Re: Better Brite

**DATE:** December 15, 2010

**SUBJECT:** Further evaluation of effectiveness of soil stabilization and potential for off-site migration of chromium contaminated groundwater at the Better Brite, Chrome Shop

<b>BETTER BRITE</b> DePERE, WISCONSIN  <b>PROPOSED</b> <b>WELL LOCATIONS</b> <b>CHROME SHOP</b>	DATE: 12/1/99
	DESIGNED: BOB
<b>HSI</b> <b>GEOTRANS</b> <small>A TETRA TECH COMPANY</small>	CHECKED: KEB
	APPROVED: JLF
	DRAWN: BOB
PROJ: F119	
<b>Figure 7-3</b>

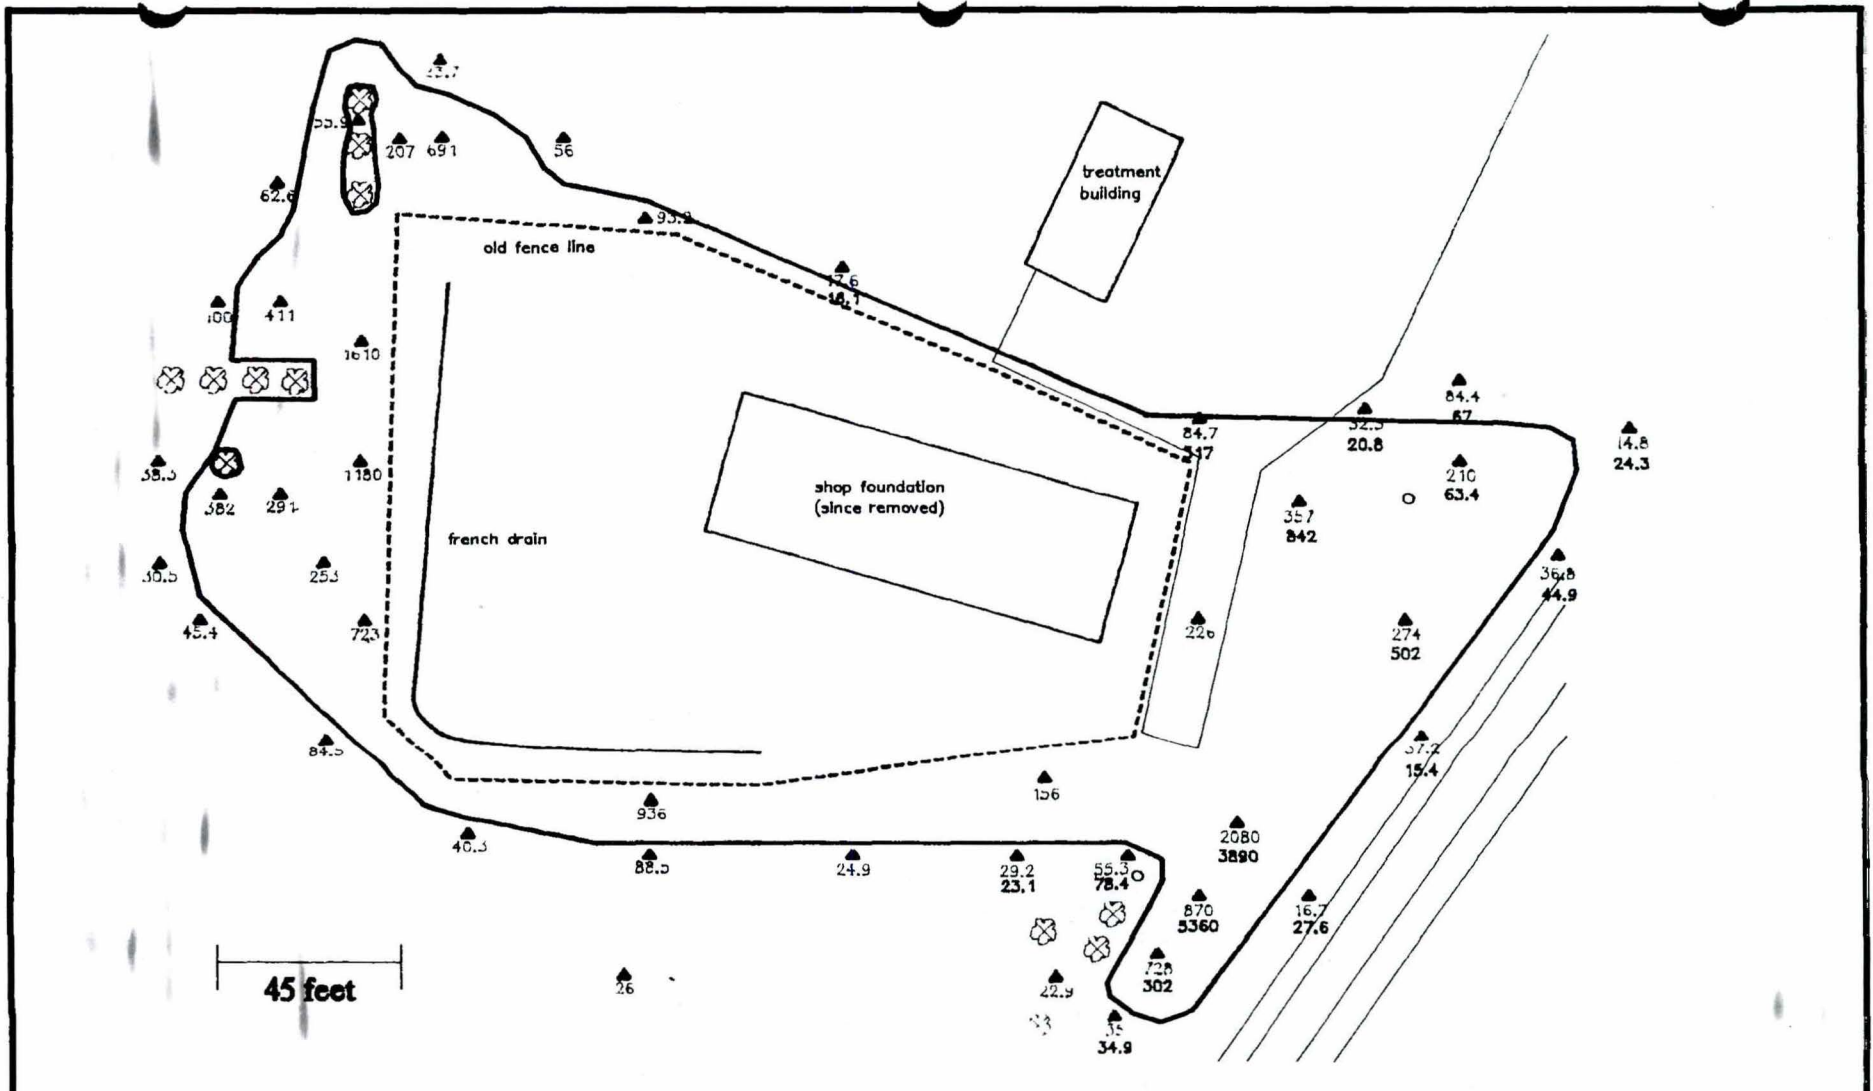
1. The sump area (see approximate limits of excavation are shown by the sump boundary on Figure 7-3). Soil was excavated to a depth of approximately 20 feet below ground surface (bgs). Soil samples collected from the bottom of the excavation confirmed that the soil left in place was not impacted with metals.

In 1999, natural soils and fill soils and gravel within the area of groundwater contamination (see Figure 7.3) were treated to a 20 foot depth by mixing with a proprietary reagent primarily consisting a blend of iron sulfates. The intention of the treatment was to reduce  $\text{Cr}^{+6}$  to insoluble and less toxic trivalent chromium ( $\text{Cr}^{+3}$ ), so that Wisconsin groundwater standards would be achieved quickly and no further groundwater withdrawal or treatment would be required. In addition in 1999, the Chrome Shop groundwater treatment plant was relocated to the Zinc

<b>BETTER BRITE DePERE, WISCONSIN</b>		DATE: 05/18/95
<b>CHROME SHOP SURFACE SOIL EXCAVATION EXTENT 1993</b>		DESIGNED: RAG
		CHECKED: JEN
		APPROVED: JLF
		DRAWN: RAG
		PROJ: 301483158
<b>HYDRO-SEARCH, INC.</b> A Tetra Tech Company		<b>Figure 2-13</b>

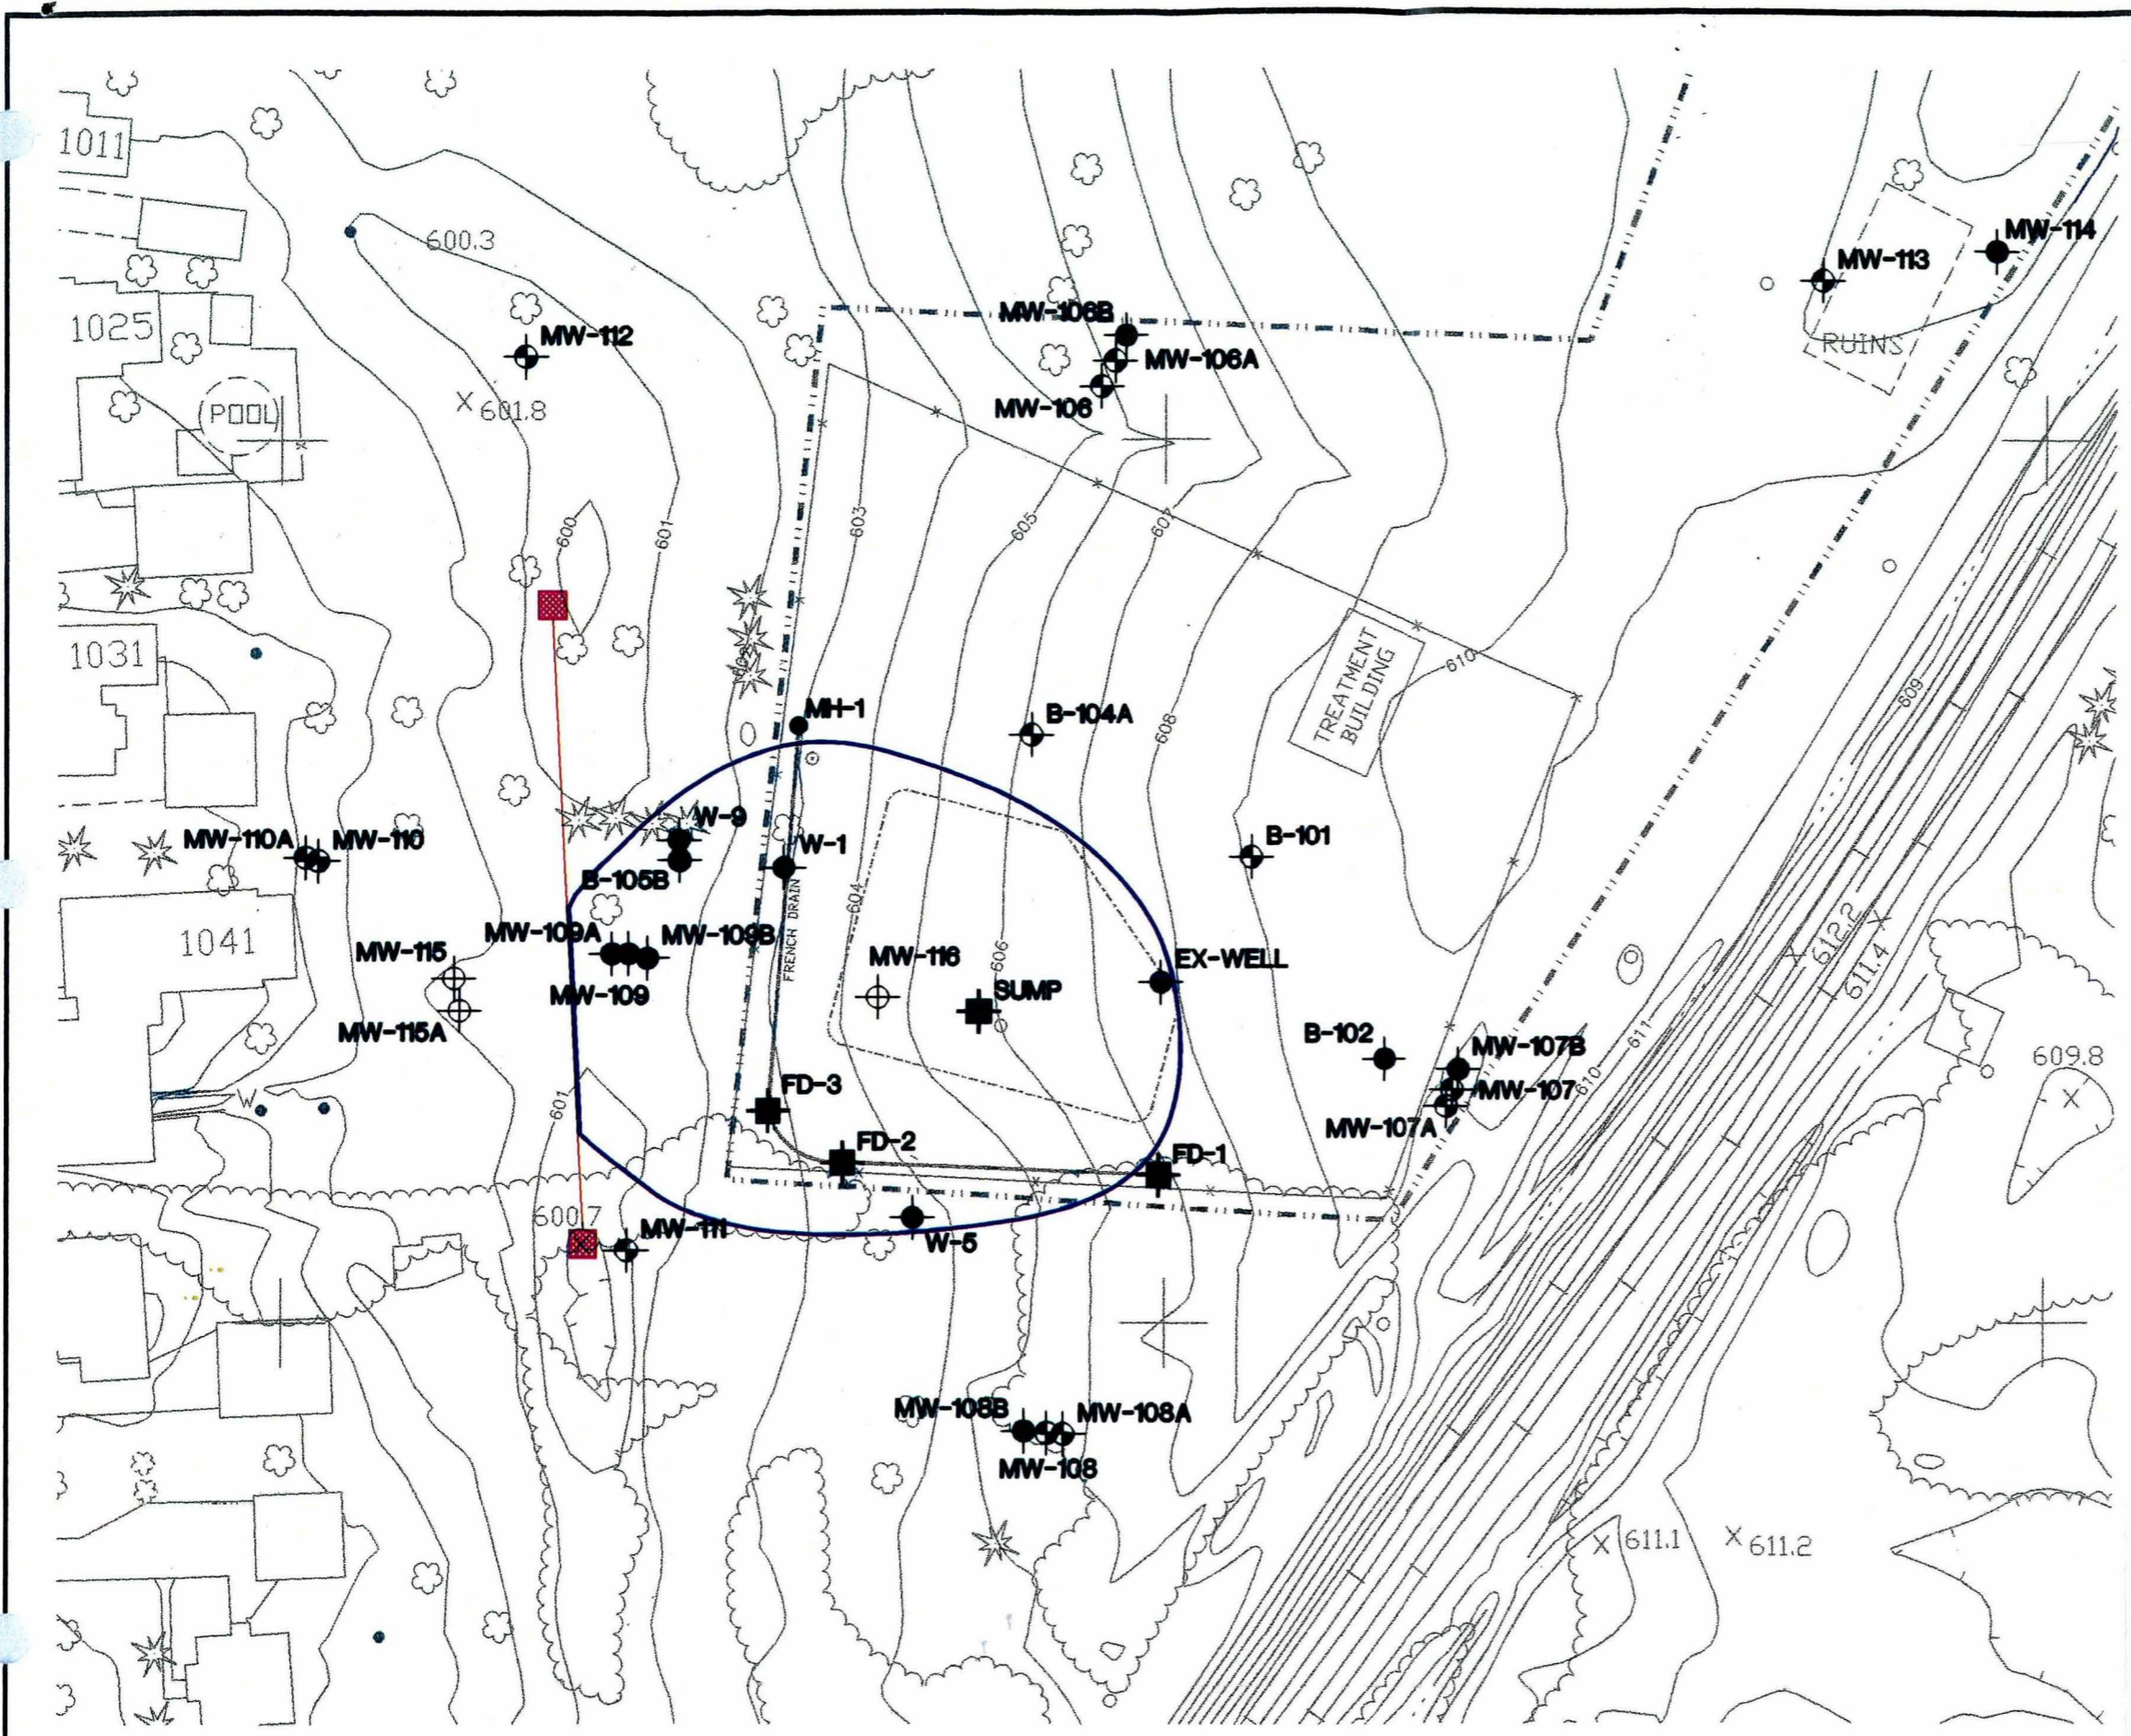
2. sand fill beneath the foundation.
3. surface soil from around the Chrome Shop and on properties adjacent (see attached Figure 2-13 from *Remedial Investigation Better Brite Plating, Inc.*, Hyrdo-Search, March 13, 1996). Surface soil was excavated to depths of approximately 1.0 to 1.5 feet. Analytical data for surface (0 to 0.5 feet bgs) and subsurface (2.5 to 3.0 feet bgs) soil samples collected from across the Chrome Shop and adjacent properties were used to define the extent of surface soil impacts and direct the excavation activities. This data along with the removal of garden soil by Better Brite in 1980 indicates that contamination from surface run-off extended well beyond the Chrome Shop property.

Considering the slow rate of groundwater movement, that the French drain started in operation only one year after start of the Chrome Shop operation, and that the area of soil contamination includes the area of groundwater contamination (compare attached figures), it appears that the groundwater contamination by chromium outside of the property boundaries (about 50 feet to
